DEPARTMENT OF PLANNING

SUBJECT: Section 75W modification request for amendments to the layout and number of units at 23 Bennelong Parkway, Wentworth Point, Auburn **(MP09 0160)**

PURPOSE

Figure 2 – Building Heights of Building B

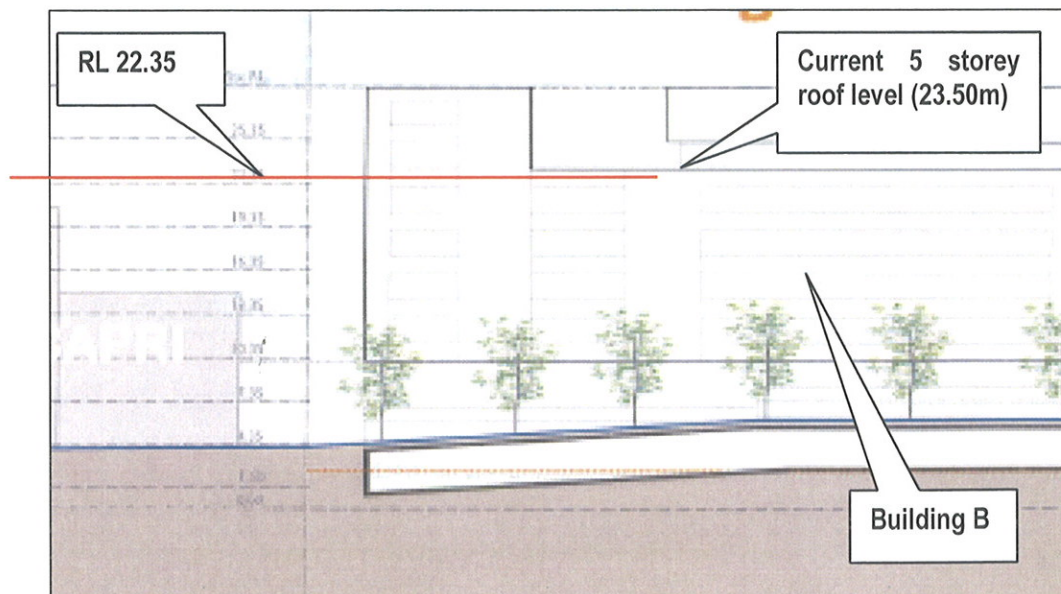
The Proponent proposes to modify the height of Building B at the south-east corner from the approved RL 22.35m to RL 23.50m. The increase in height of 1.15 metres will allow the south-east corner of the building to align with the remaining fifth floor element of the building. The additional height above the actual ceiling level of the fifth floor (as conditioned – RL 23.35m) provides for such facilities as roof plants. This increase in height will also provide consistent floor to ceiling heights within the building. This is illustrated by Figure 2.

The Department considers the additional height (1.15 metres) to be minor and reasonable given that allowances for such facilities should be included within approved building envelopes at Concept Plan stage. The inclusion of such an allowance would also be consistent with the other

Figure 3 – Proposed Building Envelope of Buildings B and C

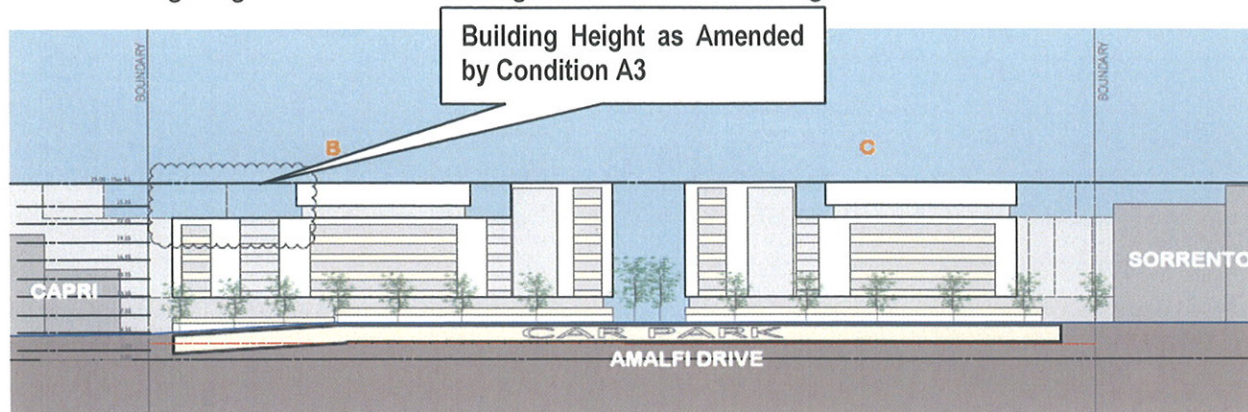
approved building envelopes throughout the development and would also allow for consistent roof to ceiling heights within the buildings as outlined within Figure 3 below.

Figure 6 – Proposed Building Separation

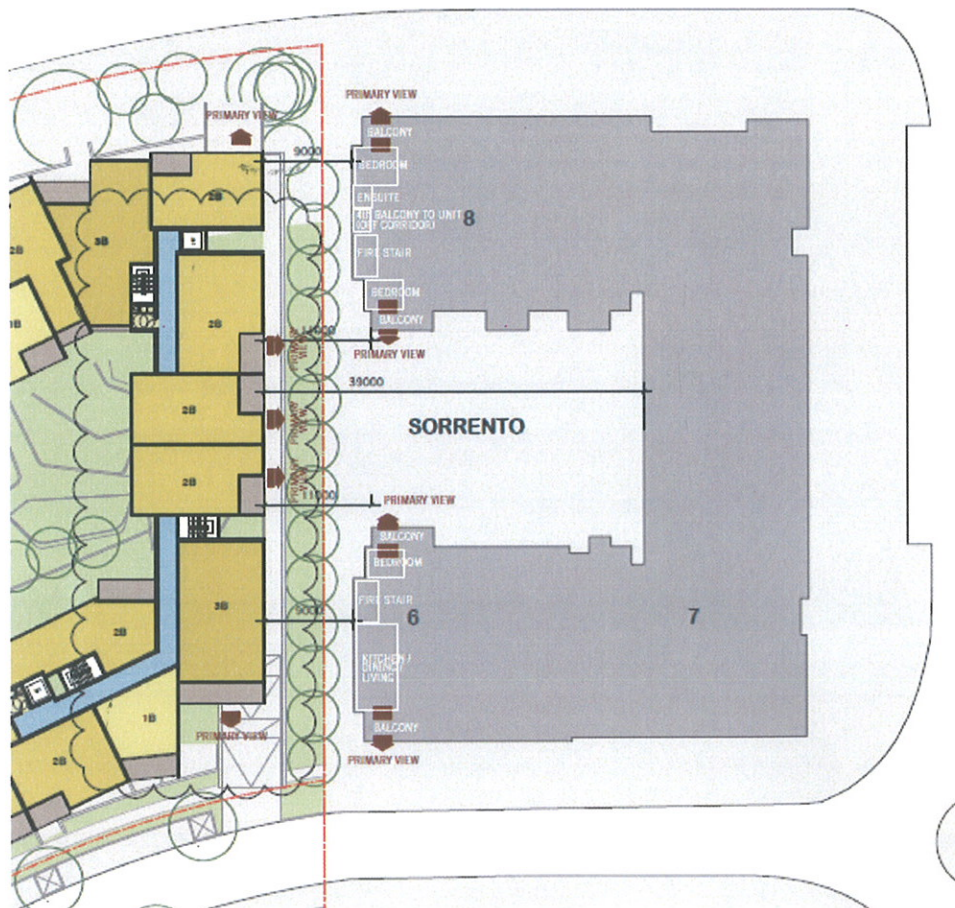
The modification will preserve the approved 9 metre setback between Building C and the existing Sorrento Building located to the north. The proposed 8 additional units within the infill section are orientated towards the open courtyard of the Sorrento Building and not existing residential units. To ensure that privacy between units is protected, appropriate screening devices could be incorporated into the final design submitted at the detailed design stage.
